1. **Official Plan Amendment and Zoning By-law Amendment – 1560 Scott Street**  
**Modification du Plan officiel et Modification du Règlement de zonage –**  
**1560, rue Scott**

**File Number: ACS2021-PIE-PS-0131**

**SUBJECT: Official Plan Amendment and Zoning By-law Amendment – 1560  
Scott Street**

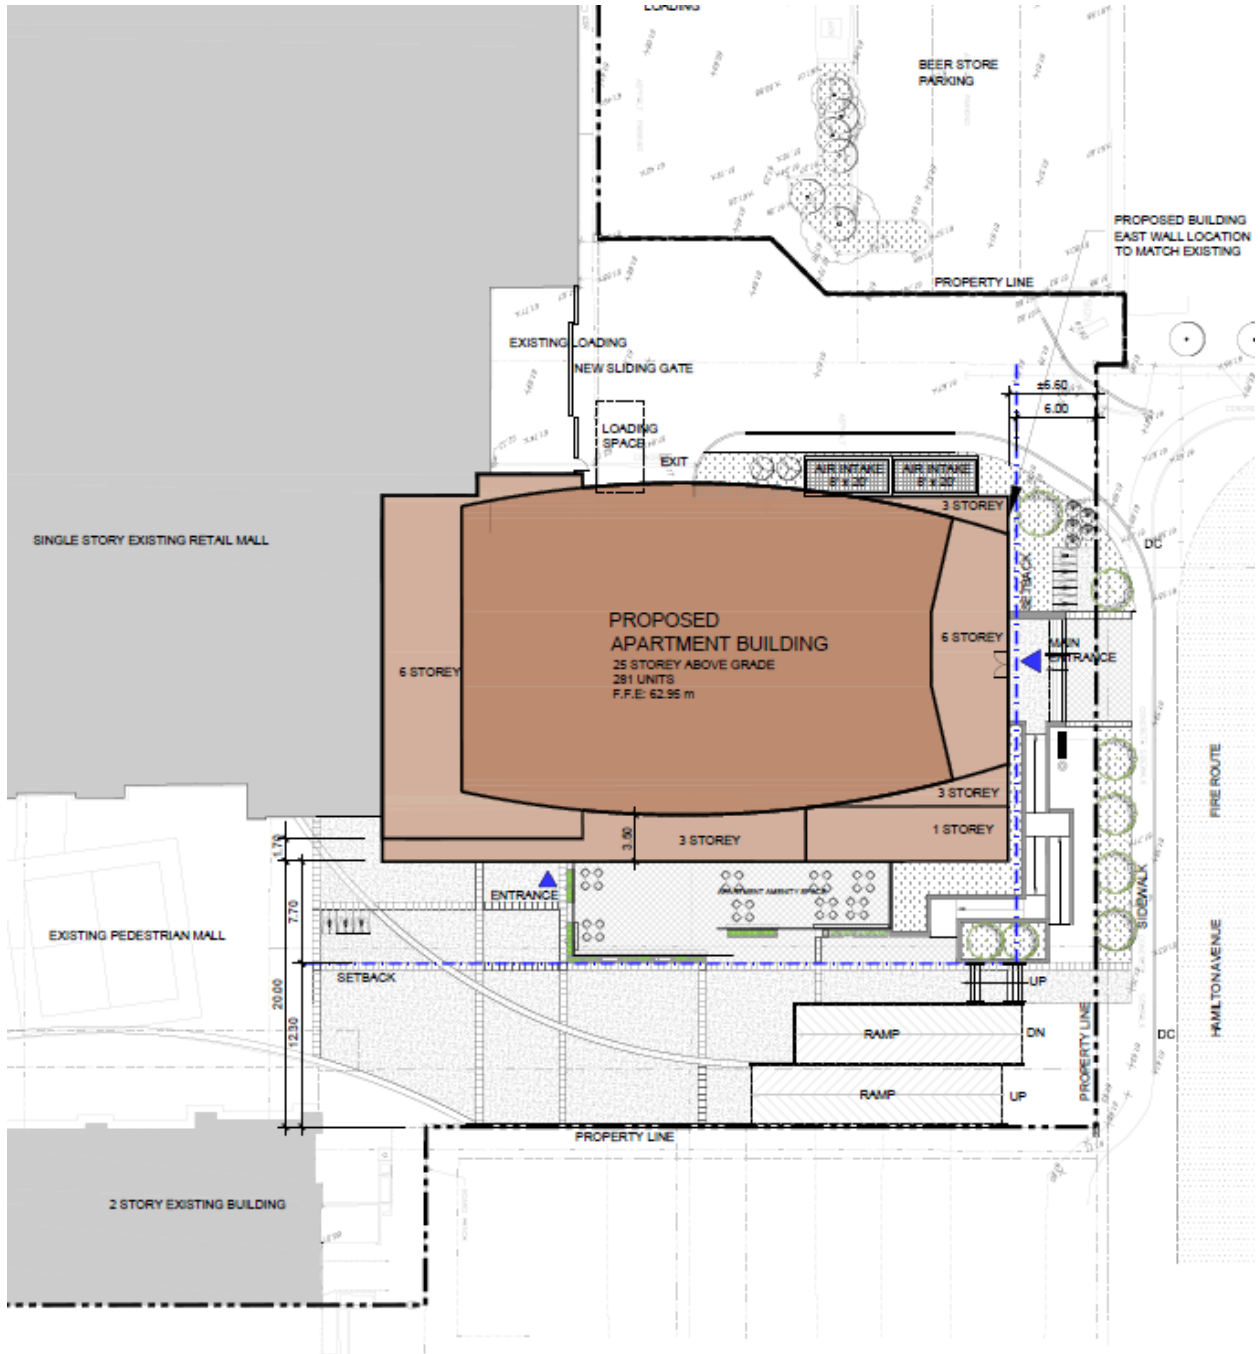
Amend Schedule B – Maximum Building Heights of the Scott Street Secondary Plan by amending the designation of the subject site's from "Up to 18 Storeys" to "Height Limit Varies as per Existing Zoning".

Document 4 – Revised Zoning By-law Schedule 100

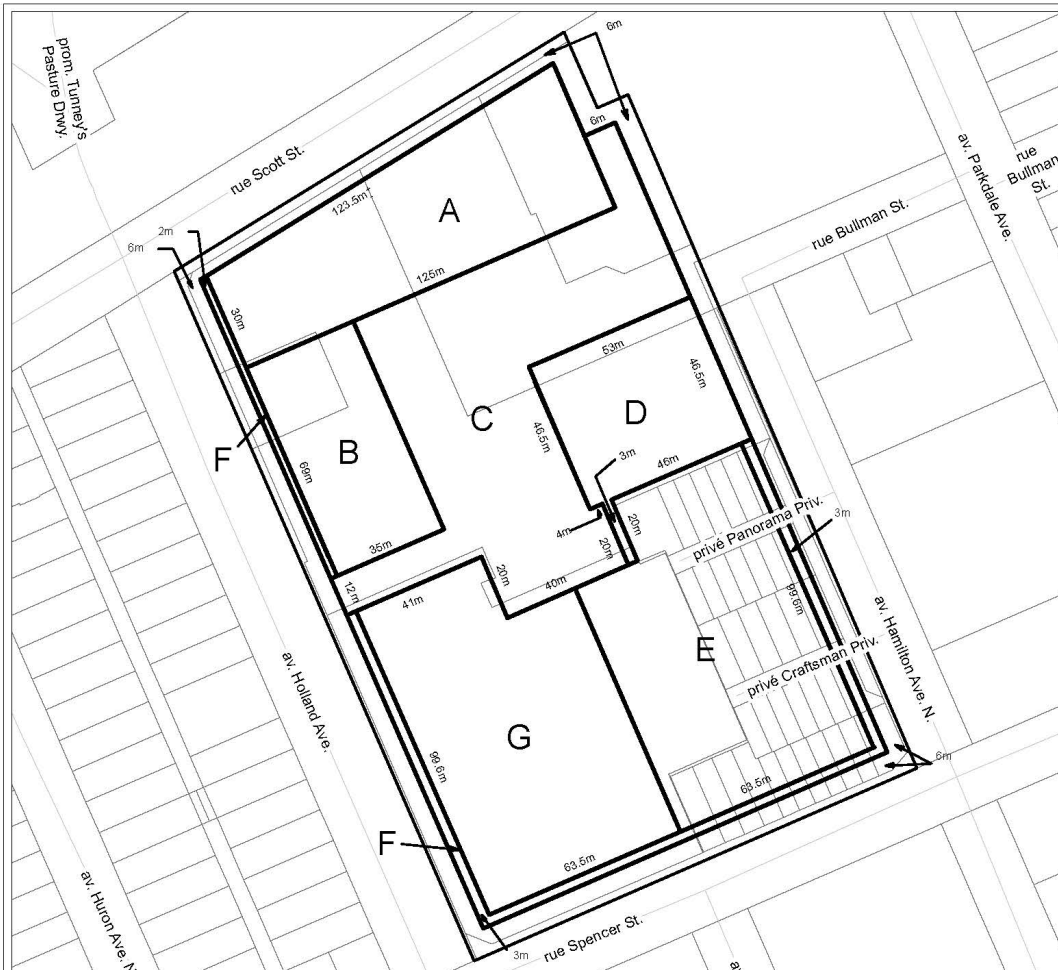
2. To amend Area D of Schedule 100 by changing the maximum permitted height from 112 metres ASL to 140 metres ASL 25 storeys, as shown in Document 4.
